Item Name: Crosstube Turning Detail

DART AEROSPACE LTD	Work Order:	105233
Description: Crosstube Assembly (412 High Aft)	Part Number:	D412-664-243
Inspection Dwg: D412-664-243 Rev: E		Page 1 of 2

DRAWING NO. D412-664-243	TITLE CROSSTUBE ASS'Y (412 HI AFT)	REV. E	DART AEROSPACE LTD ENGINEERING ORDER		D.E.O. NO. D412-664-243-E-2	SHEET NO. SHEET 1 OF 1	SCALE NTS
DRAWN <i>WP</i>	CHECKED <i>ASS</i>	MFG. APPR. <i>R</i>	APPROVED <i>WP</i>		DE APPR. <i>WP</i>		
DATE 11.09.07	DATE 11.09.19	DATE 11.09.19	DATE 11.09.19		DATE 11.09.19

DRAWING NO. D412-664-243	TITLE CROSSTUBE ASSEMBLY (412 HI AFT)	REV. E	DART AEROSPACE LTD ENGINEERING ORDER		D.E.O. NO. D412-664-243-E-4	SHEET NO. SHEET 1 OF 3	SCALE NTS
DRAWN 90	CHECKED A	MFG. APPR. A	APPROVED MP		DE APPR. MP		
DATE 12.08.21	DATE 12.08.30	DATE 12.08.30	DATE 12/8/30		DATE 12.08.30

**D412-664-243
ASSEMBLY DETAIL**

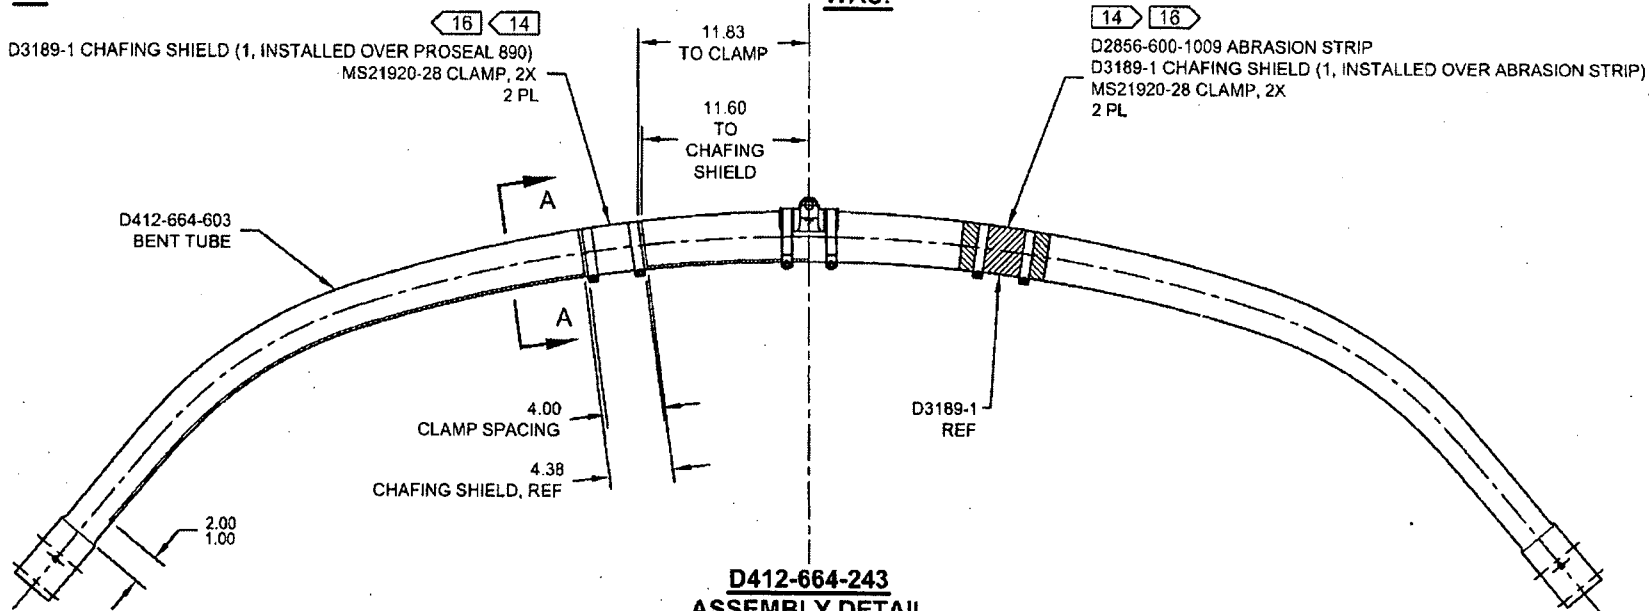
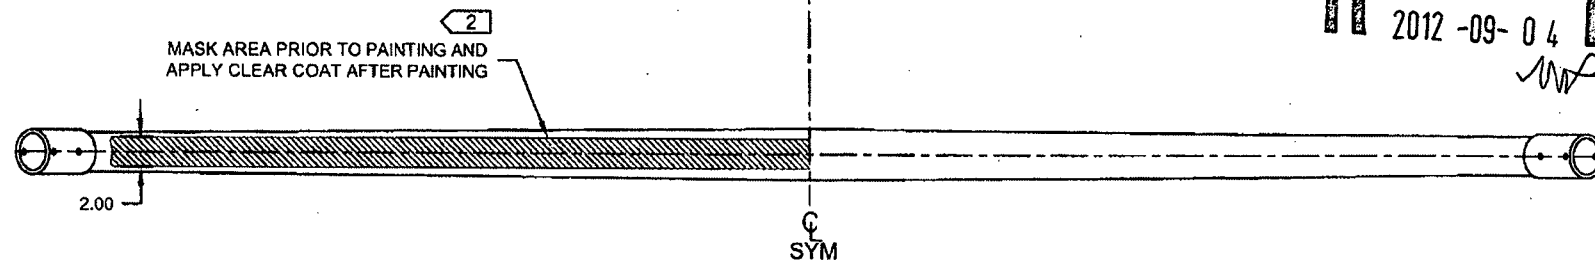
REMOVED ABRASION STRIP IN FAVOR OF A THIN LAYER OF PROSEAL 890. UPDATE INSTALLATION OF CHAFING SHIELDS AND REDUCE TORQUE TO 40-50 IN-LBS. THIS ENGINEERING ORDER SUPERCEDES DEO D412-664-243-E-1.

D3189-1 CHAFING SHIELD (1, INSTALLED OVER PROSEAL 890)
MS21920-28 CLAMP, 2X
2 PL

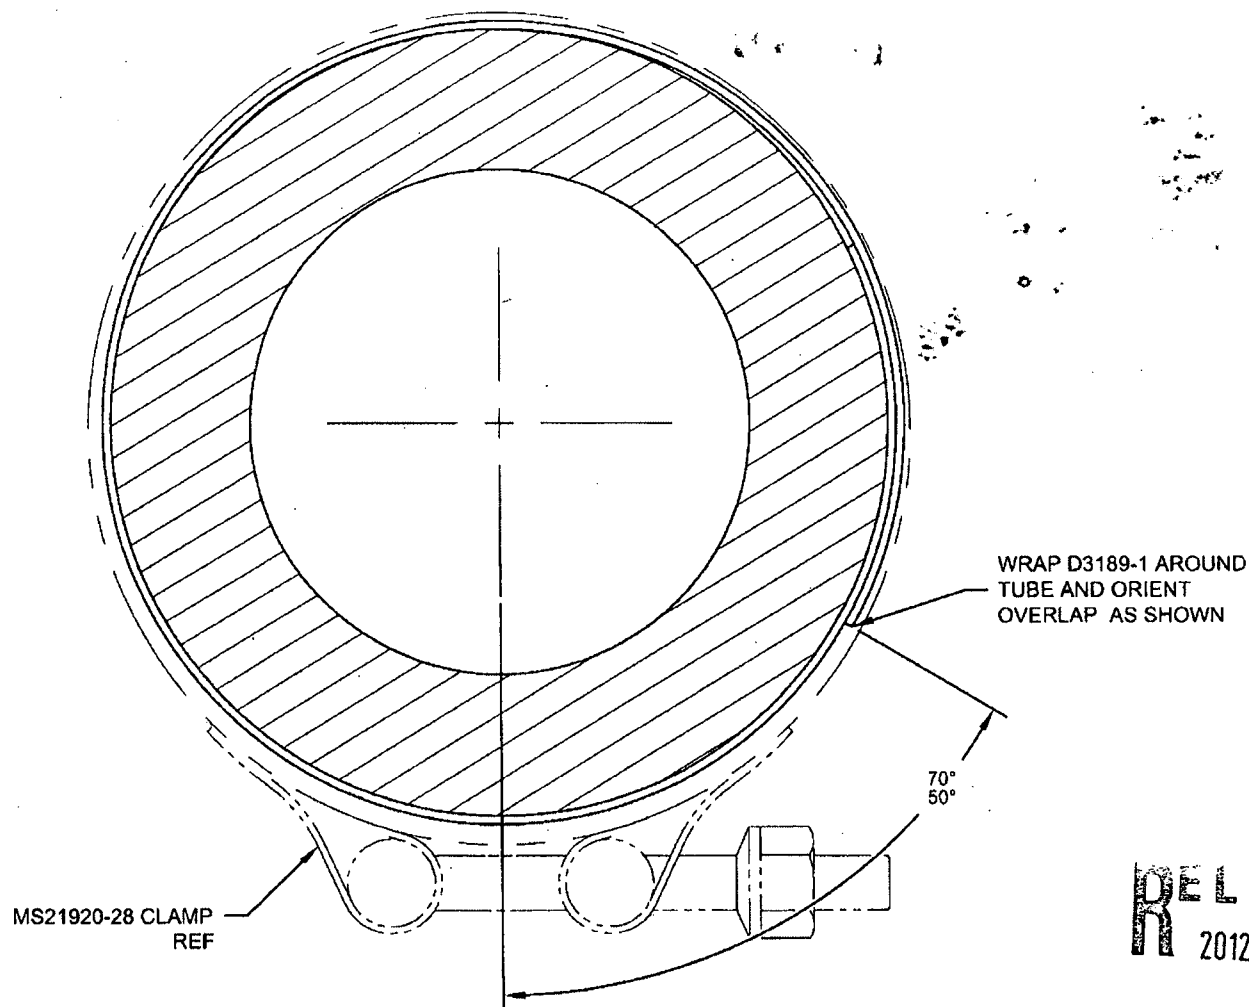
- 2) FINISH: CHEMICAL CONVERSION COAT PER DART QSI 005 4.1
PRIME INSIDE AND OUTSIDE PER DART QSI 005 4.2
MASK UNDERSIDE OF CROSSTUBE AS SHOWN (HATCHED AREA)
PAINT OUTSIDE PER DART QSI 005 4.2
AFTER PAINTING, APPLY CLEAR COAT ON HATCHED AREA
- 14) APPLY A THIN COAT OF PROSEAL 890 ON INSIDE CONCAVE SURFACE OF D3189-1 CHAFING SHIELD AND LET CURE PER MANUFACTURER'S INSTRUCTIONS. INSTALL PROSEALED D3189-1 CHAFING SHIELD ONTO CROSSTUBE BY APPLYING A THIN COAT OF PROSEAL 890 ONTO CROSSTUBE. BE SURE TO ELIMINATE ANY AIR GAPS.
- 16) TORQUE CLAMPS ON D2896-1 SUPPORT 80 TO 100 IN-LB. **TORQUE CLAMPS ON D3189-1 CHAFING SHIELD 40 TO 50 IN-LB.** ENSURE AT LEAST 1.5 THREADS SHOWING IN SAFETY AND THAT NUT HAS NOT BOTTOMED-OUT AFTER TORQUING.
